GUILDERLAND PLANNING BOARD
PLANNING BOARD
P A C K E T
JULY 12, 2023
07:00 PM

SUBJ: 3 Lot Minor Subdivision – Settles Hill Road/Furbeck Road – Michael Flocuzzio
Concept Plan Review

SUBJ: Bridge Coast Enterprises, LLC - 2555 Western Avenue – Change in Tenancy (Office)
Site Plan Review

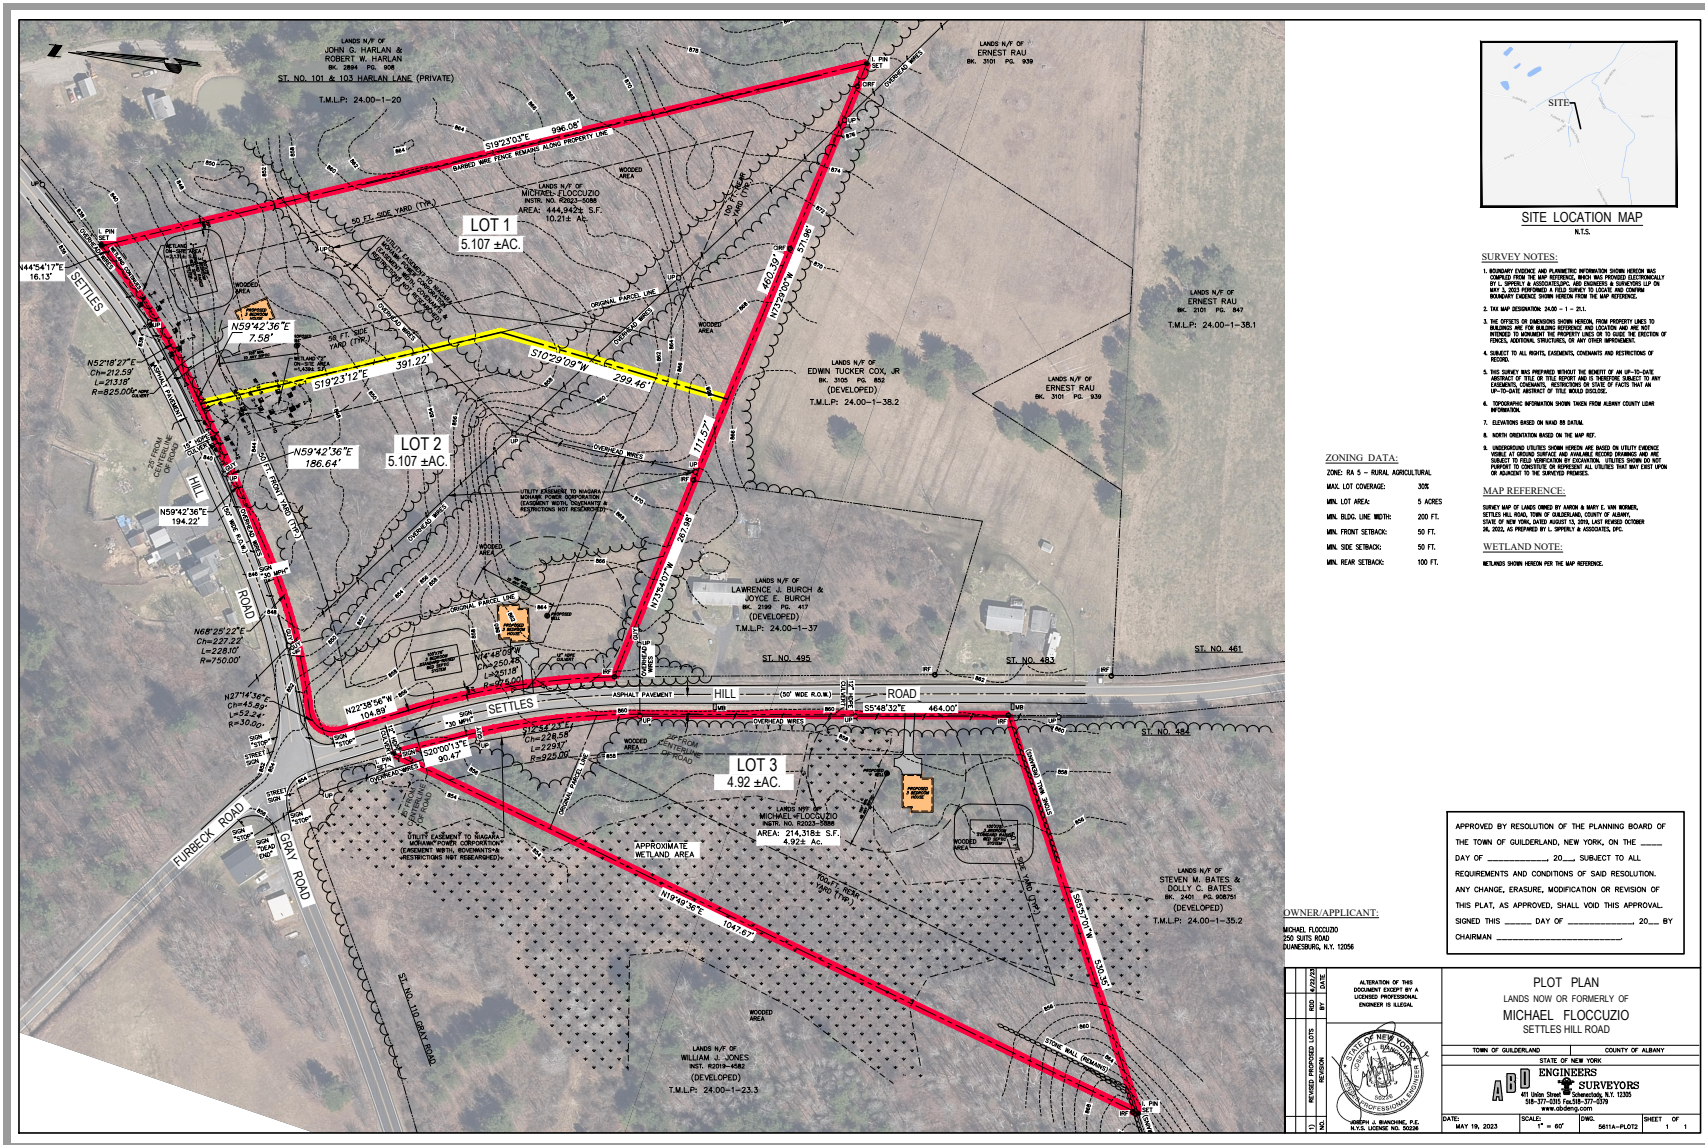
The Guilderland Conservation Advisory Council (GCAC) reviewed the application at their June 12th meeting and conducted a site visit on June 24th. The GCAC concluded GCAC does not think the development of this property will have much negative impact on the environment provided the developer does not indiscriminately cut down too many trees and that excavation is done prudently. Driveways to the residences will need to take into consideration the flow of traffic near the sharp turn of the Road at the northwest corner.

A question arose regarding the way the proposed lots are planned with three residential lots on one side of the Road and the three associated wood lots on the other side; since none of these three lots are contiguous with the lot they are associated with on the other side of the Road. None of the three residential lots appear to be contiguous with their wood lots. It should be noted that prior to the completion of this report, GCAC was informed by the Town Planner that the Planning Board did not support the layout as proposed and directed the Applicant to put two lots on one side of the Road and one lot in the area where the 'p/o' lots are proposed. Thus, it appears that if the Applicant agrees to do so, GCAC may be requested to review the amended plan and determine what environmental impact the revised layout will have.
